In re: Application of Pennsylvania-American Water Company for  
Approval of the Right to Offer, Render, Furnish or Supply  
Wastewater Service to the Public in an Additional Portion of  
Fairview Township, York County, Pennsylvania  
**Docket No. A-2024-3050785**

**PAWC Responses to TUS Set I**

**Amended Response to A-15**

# ATTACHMENT 2 TUS A-15.b Attachment

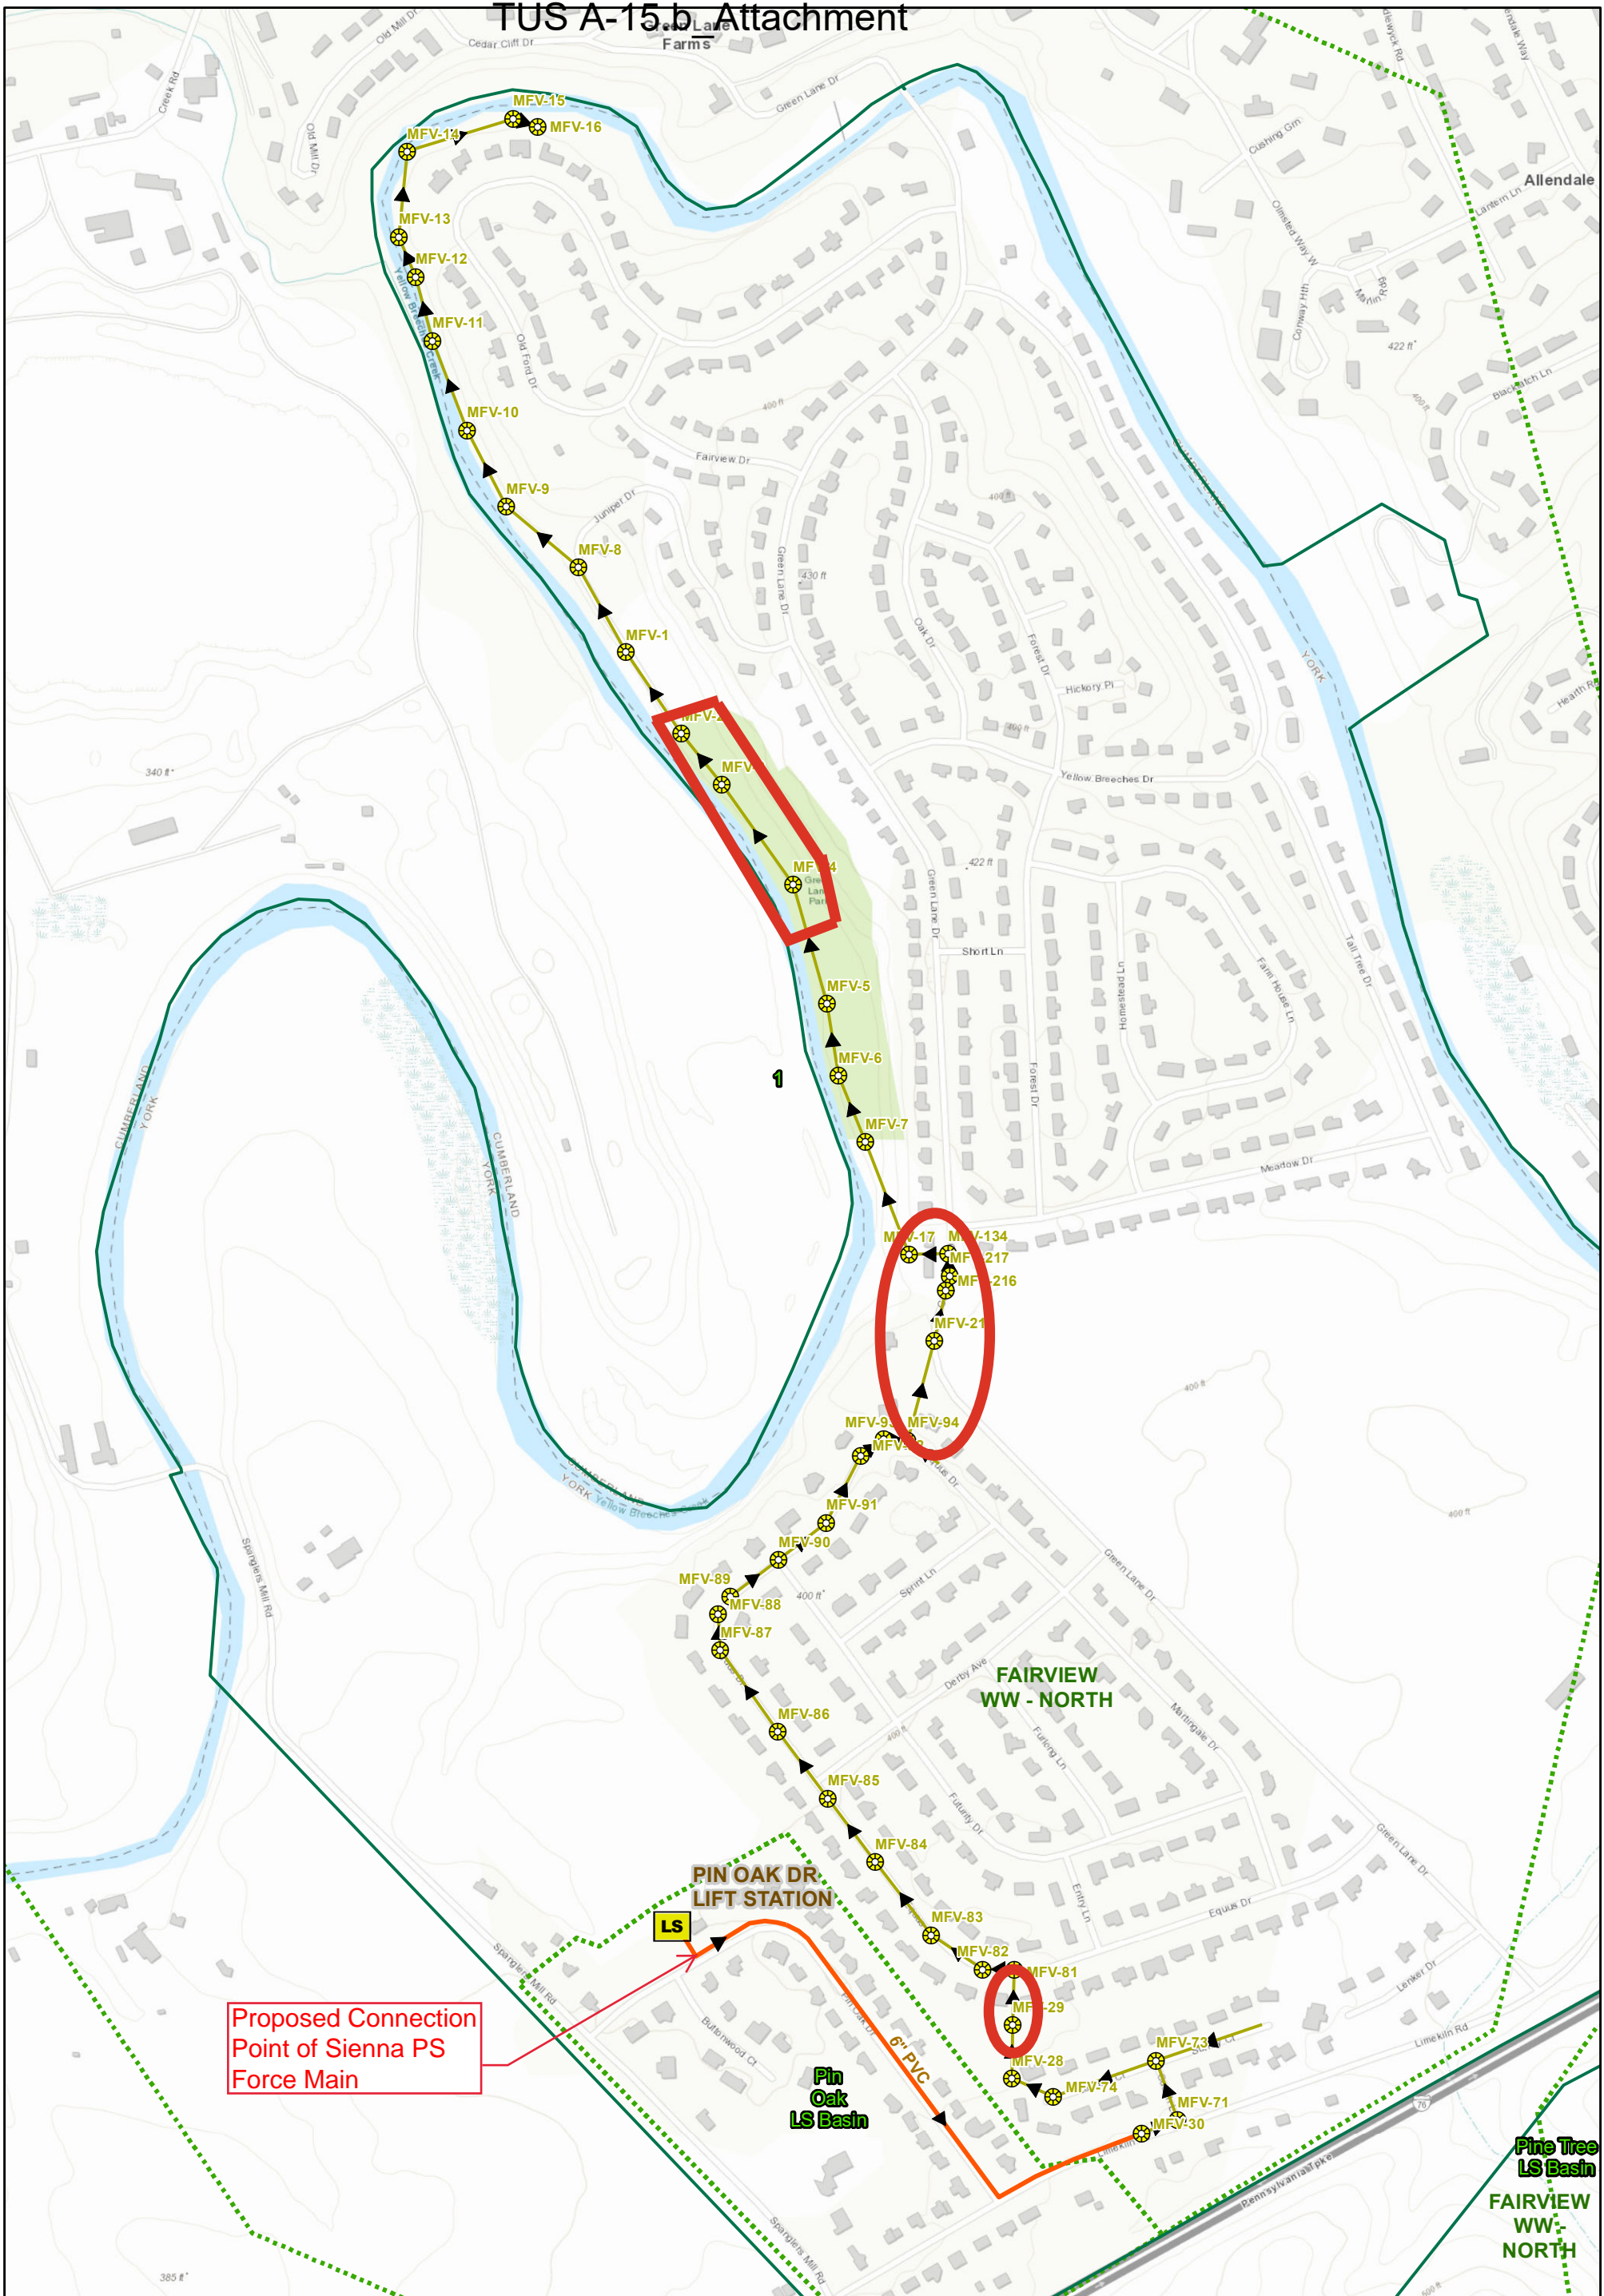
**A-15.** The 2022 Plot Map depicted a force main connection with PAWC-WD’s existing collection system within Pin Oak Drive. Considering this connection, please provide responses to the following:

- a. Identify PAWC-WD’s existing facilities, including the material type, size, and capacity, to be used to convey flow from the requested service territory to the Lower Allen WWTP;
- b. Provide evidence that PAWC-WD’s existing facilities have adequate capacity to provide wastewater service to the requested service territory; and
- c. Identify any required upgrades to PAWC-WD’s existing facilities to be used to provide wastewater service to the requested service territory and the estimated cost of these upgrades.

- a. Please see attached **TUS-A-15.a\_Attachment**, which is the Sienna Sanitary Sewer Capacity Reserve Capacity Analysis – PAWC (Fairview Township) to Lower Allen Township WWTP, and the Sienna Sanitary Sewer Capacity Reserve Capacity Analysis – Sienna to PAWC (Fairview Township). These analyses include the pipe size, type, and carrying capacities.
- b. Please see attached **US-A-15.b\_Attachment**, which is the draft Act 537 Special Study for the Lower Allen Township WWTP, and the Fairview Township Service Area, identifying the required upgrades to PAWC’s collection system. All required upgrades will be completed and certified by the DEP before the Development is connected to PAWC’s collection system.
- c. Please see attached **TUS-A-15.b\_Attachment**, Attachment 10 “OPINION OF PROJECT COSTS”.

The areas with future undersized pipes were identified in the Sienna pump station and collection system application. A plan of the Fairview Service area that receives the wastewater discharge from the Sienna and Buttonwood Pump Station common force main is shown in Attachment 2.
